August 9, 2018
Staff Report to the Southeast Town
Design Review Committee

CASE #MPL2018-10028
CASE #SUB2018-10036
Item # 1

LAKE NONA PARCEL 10 RESIDENTIAL PHASE 1

ROAD CROSS SECTIONS

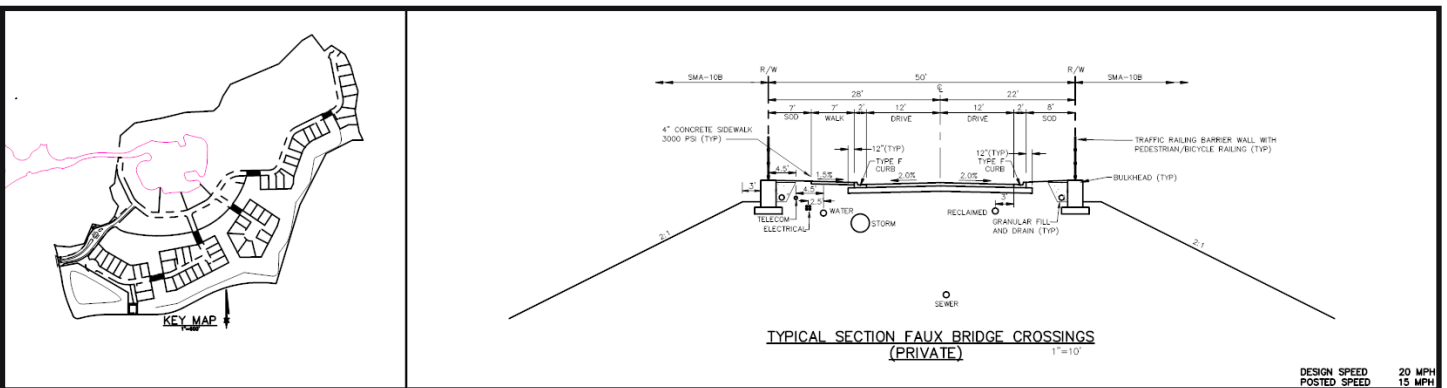
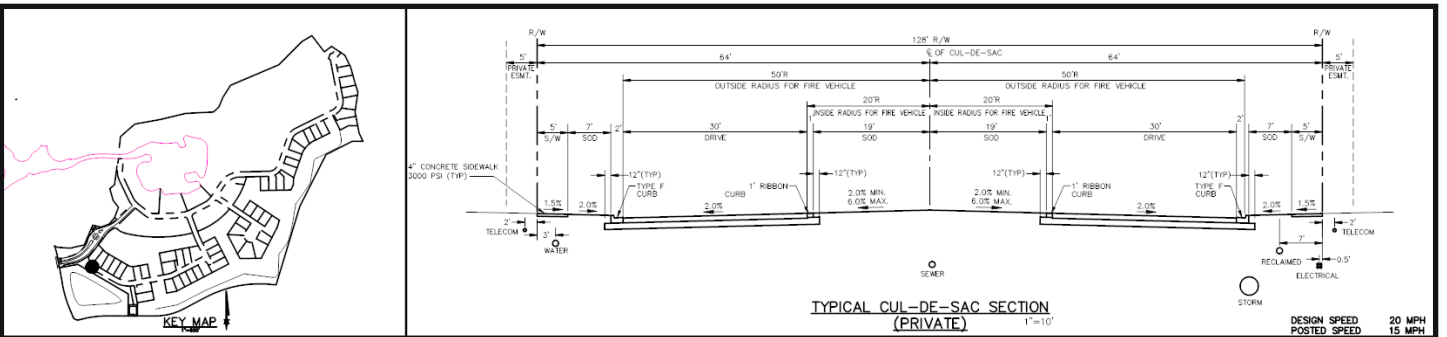
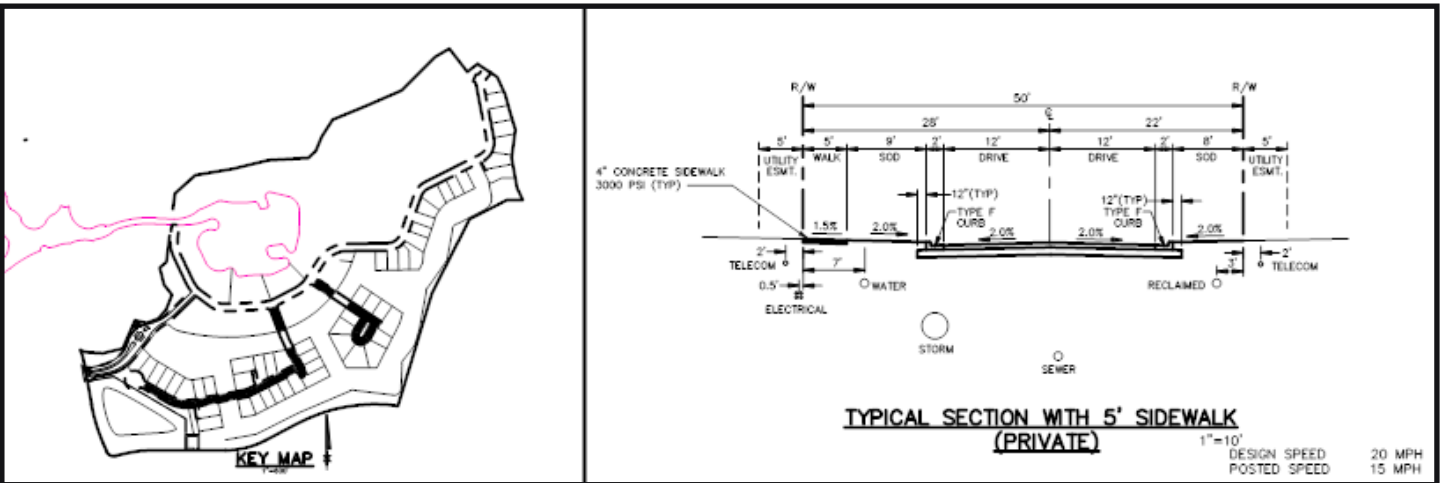
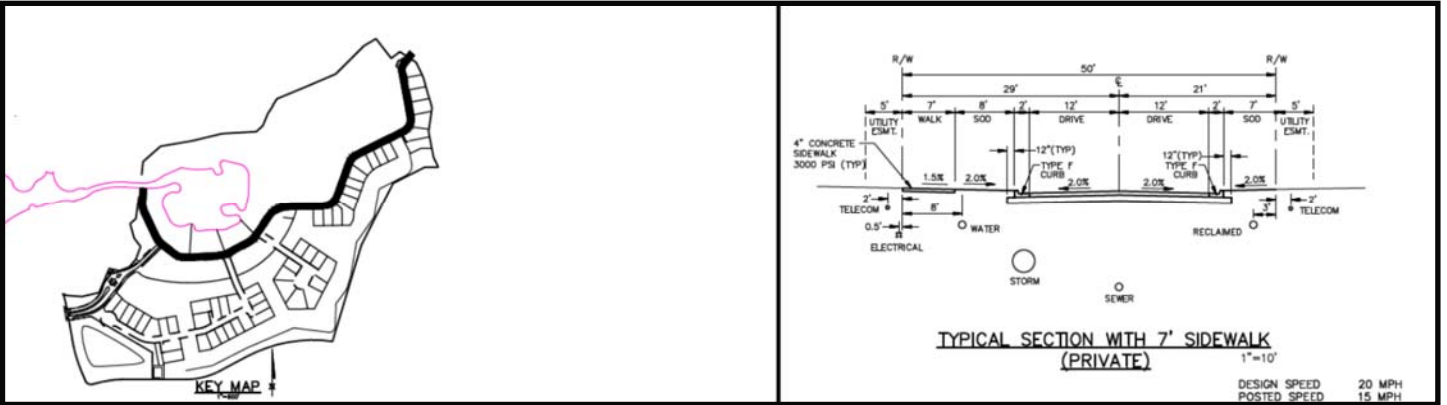
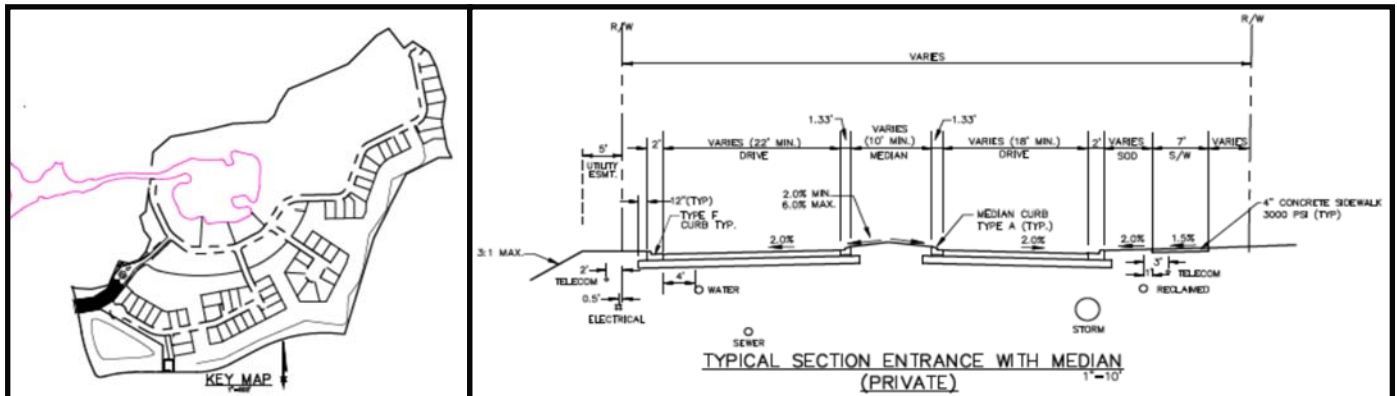
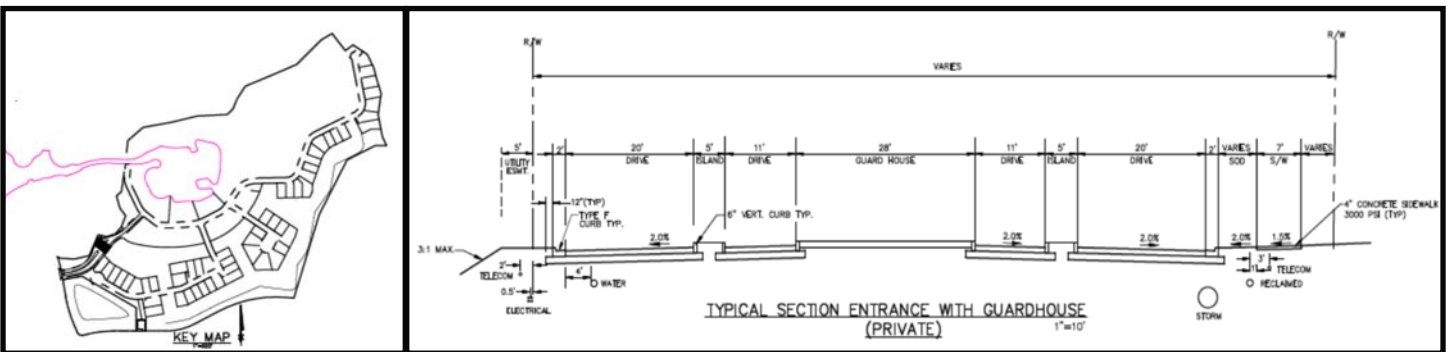
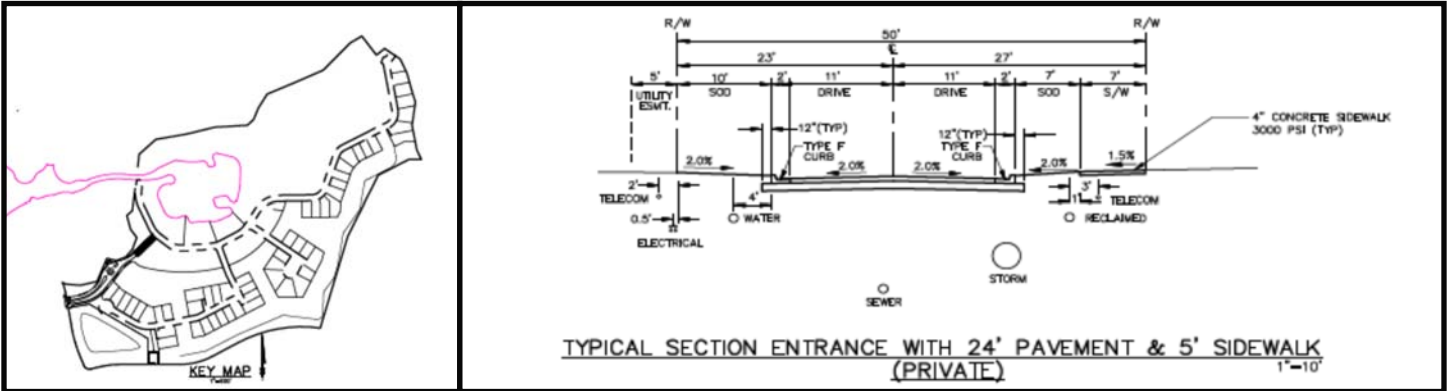
The Southeast Plan contains a section on the Local Circulation System as well as a discussion of roadway connectivity. These standards are to ensure that the proposed development has an interconnected system of arterial, collector and local streets; bicycle lanes; multi-use trails; transit; traffic calming; and parking standards. The intent of the Southeast Orlando Sector Plan's Transportation Design Standards are to assist in creating a sustainable community with a more balanced transportation system. The proposed Lake Nona SPMP has been reviewed for conformance with this section of the LDC Chapter 68. The applicant has submitted a road cross-sections that will serve this development. All roadways within are private roadways. The typical cross-sections can be found on pages 12-14 of this report.

PEDESTRIAN PLAN

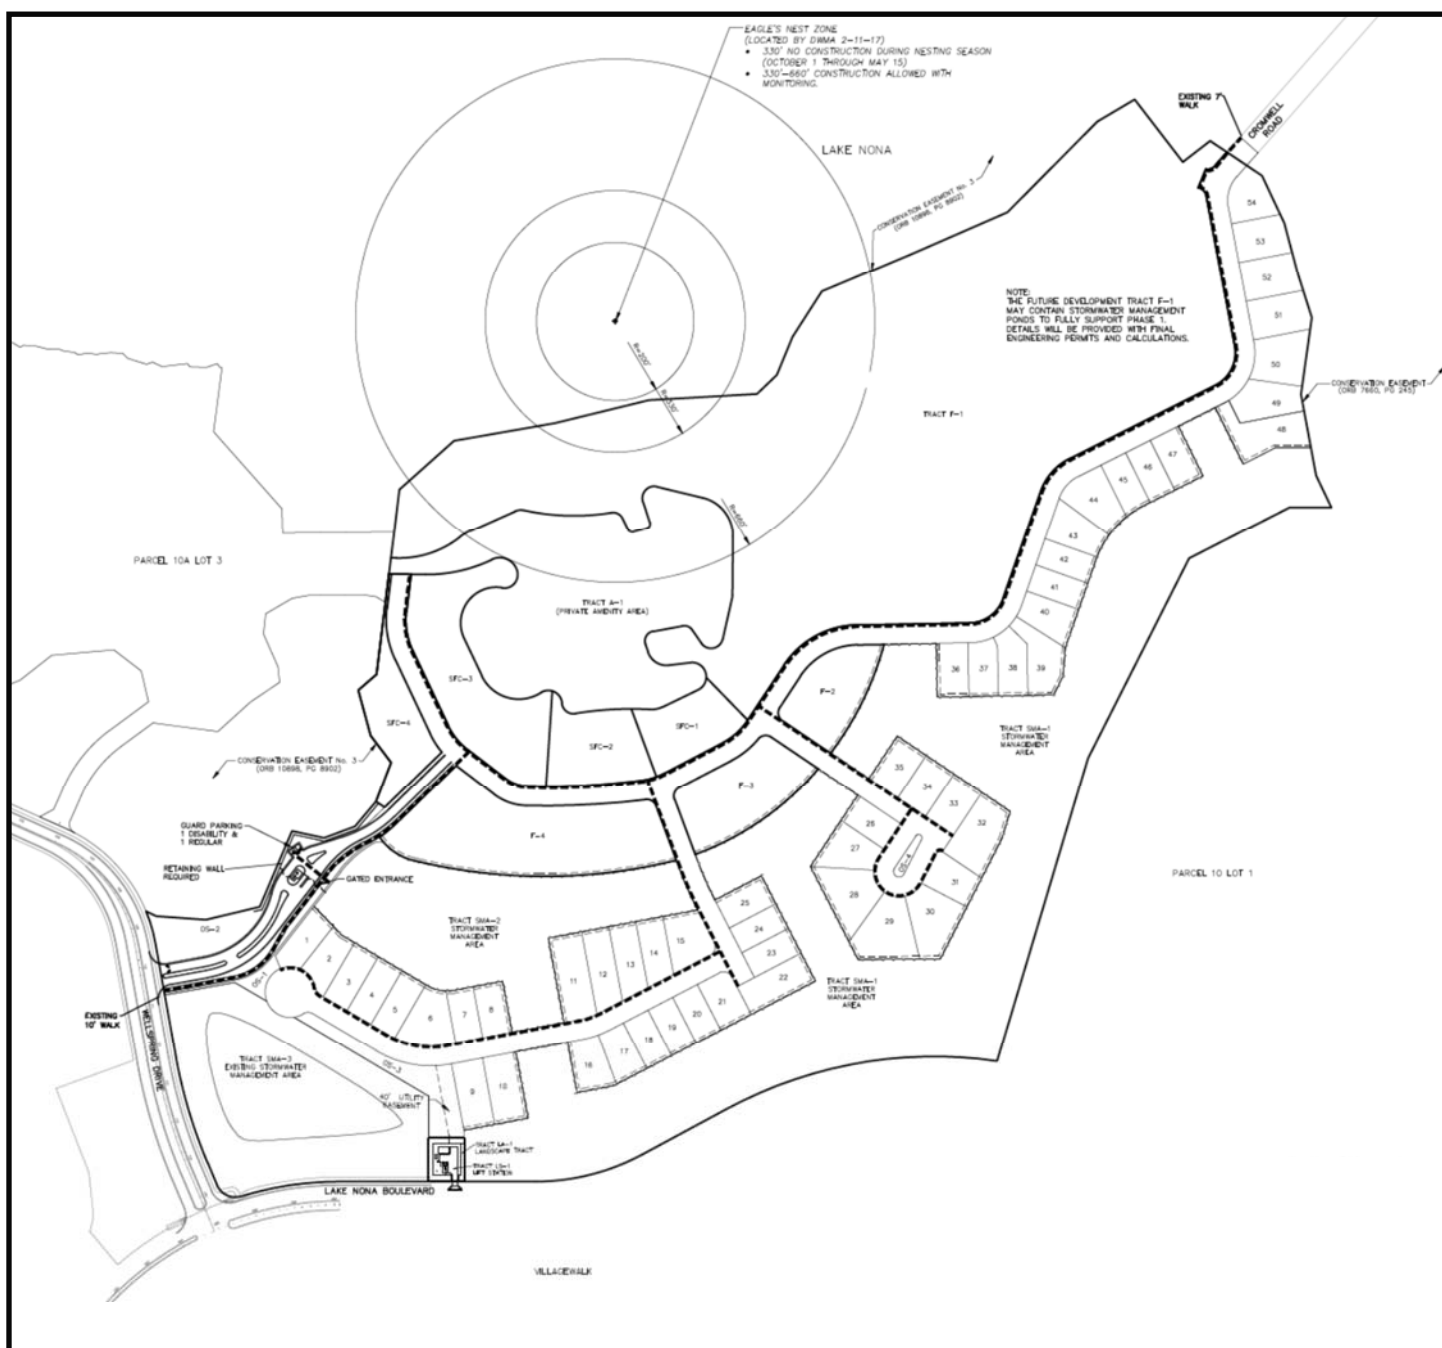
The applicant has requested an alternative development standard to allow sidewalks on one side of the road for the single-family residential lot development. Due to the nature of this residential community and the established development pattern within the Lake Nona Golf & Country Club, staff recommends approval of this alternative development standard. Future sidewalks may be required when Parcels SFC-4 and F-2/F-3/F-4 are reviewed by the Southeast Town Design Review Committee.
